# ***Interactive comment on “Evaluation of GPM IMERG Early, Late, and Final rainfall estimates with WegenerNet gauge data in southeast Austria” by Sungmin O et al.***

**Sungmin O et al.**

Received and published: 22 June 2017

Fig. 1.

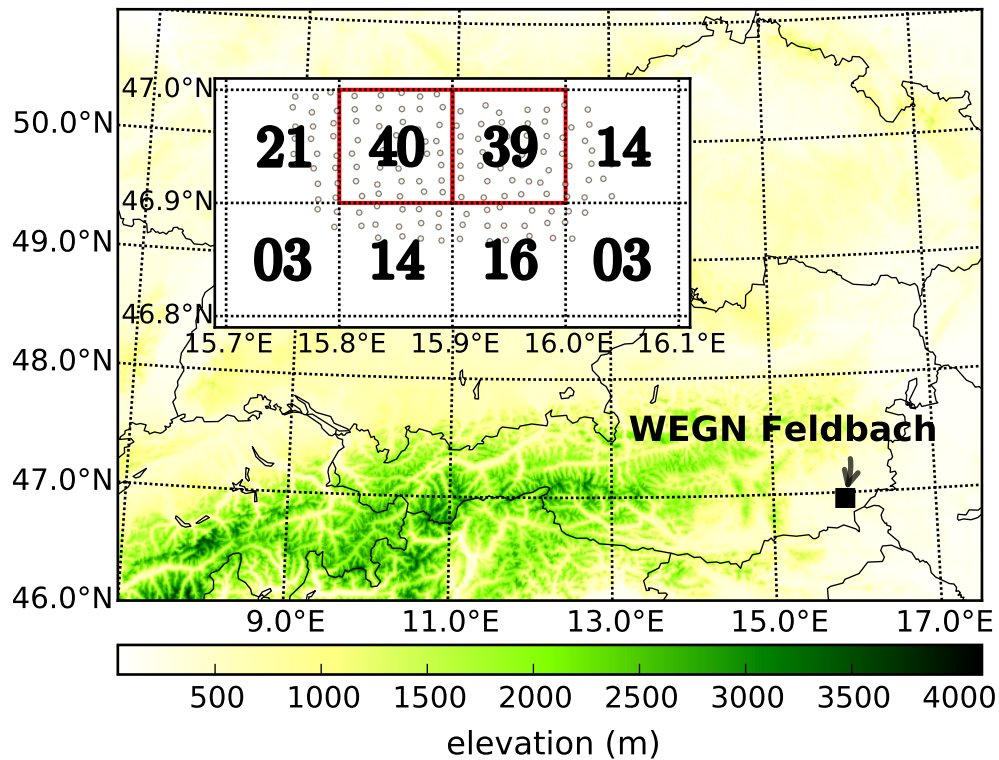
#3 Figure 1. What is the red dot in the map? Does it contain the two grids in red?

***It was referring to the location of WegenerNet network; Feldbach in Austria. We assume the red color made it confusing, so we have converted the mark in black (new figure is attached). Also the caption of Fig.01 will be; "... the Feldbach region (black square) ...".***

Fig. 2.

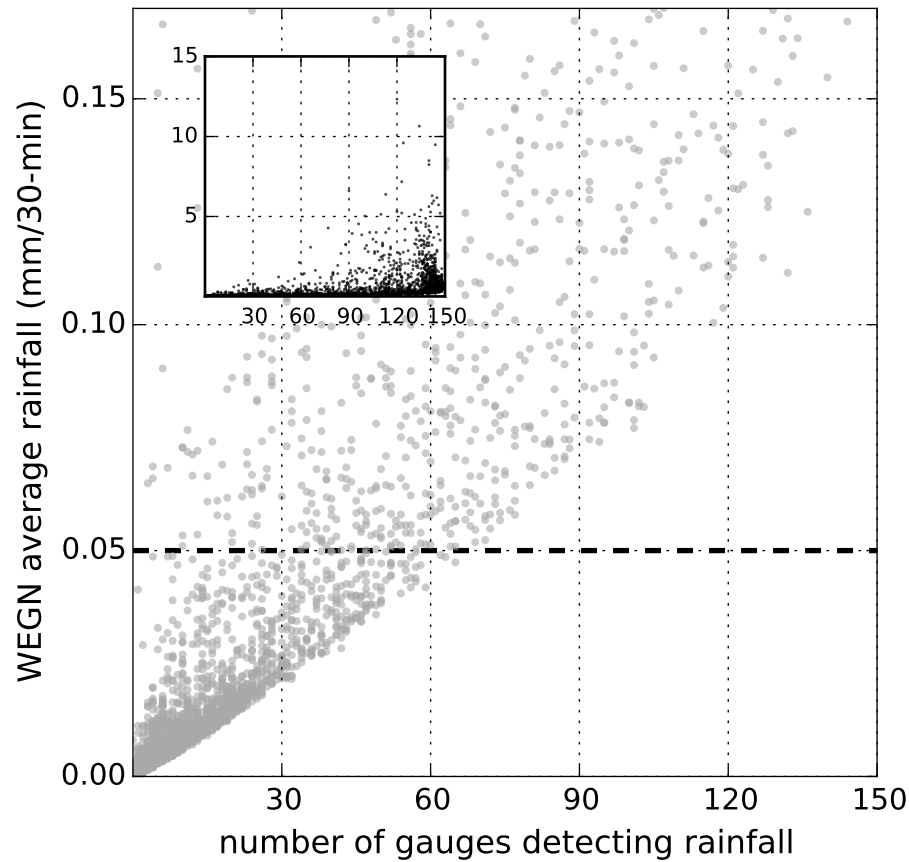
#1 Fig. 2 is very useful to characterize the uniformity of gauge rainfall measurement. Is that possible to expand the rain rate above the current  $\sim 0.16 \text{ mm}/30 - \text{min}$ ?

#6 Figure 2. What time period? It is not clear.

***We limited the y-axis to emphasize where our interest lies, i.e., very low rain rates. An inset plot will be added in Fig.2 (attached) to show higher rain rates.***

***The time period is same as the study period. “... (April to October in 2014-2015)...” will be added in the caption of Figure 2.***
